Customer No.: 31561
Application No.: 10/064,882
Docket NO.: 7857-US-PA

REMARKS**Present Status of the Application**

AMENDMENTS TO DRAWING FIGURES:

FIG. 1

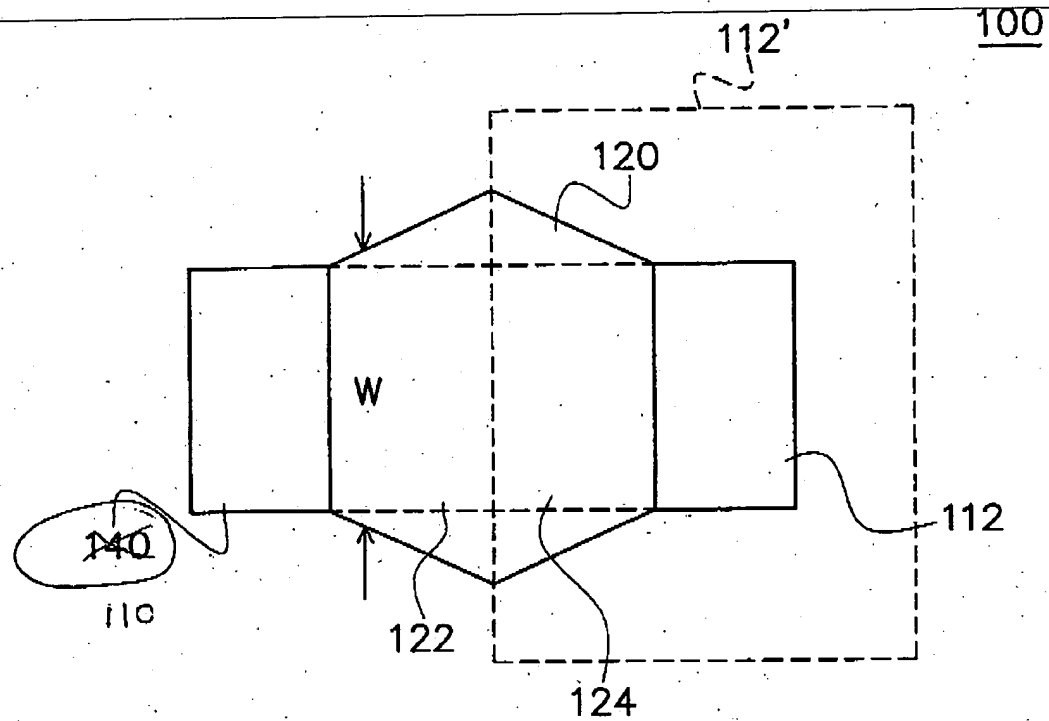
1. The Office Action objected to the drawings for failing to comply with 37 CFR 1.84 because reference character 140 has been used to designate both a drain region and a channel region. The drawing is further objected to for the reference "112" mentioned in the description is not included in the drawings.

2. The Office Action objected to the drawings for failing to comply with 37 CFR 1.84(p)(5) because they include the following reference sign(s) not mentioned in the description: 112' in Fig. 1.

Please Amend the Drawing Figure 1 as shown in red ink and as presented in the
replacement figure 1.

In response thereto, Applicants have proposed to amend the drawings as a separate accompanying pages. After entry of the proposed amendments to drawings, it is believed that the above objections can be overcome. Reconsideration is respectfully requested.

Further, with regard to reference "112", the Examiner's attention is kindly directed to Figs. 1-3, where the reference "112" is shown to represent "a source region". Accordingly the above objection is moot. Reconsideration is respectfully requested.

In response thereto, Applicants have amended the specification. After entry of the above amendments to specification, it is believed that the above objection can be overcome. Reconsideration is respectfully requested.
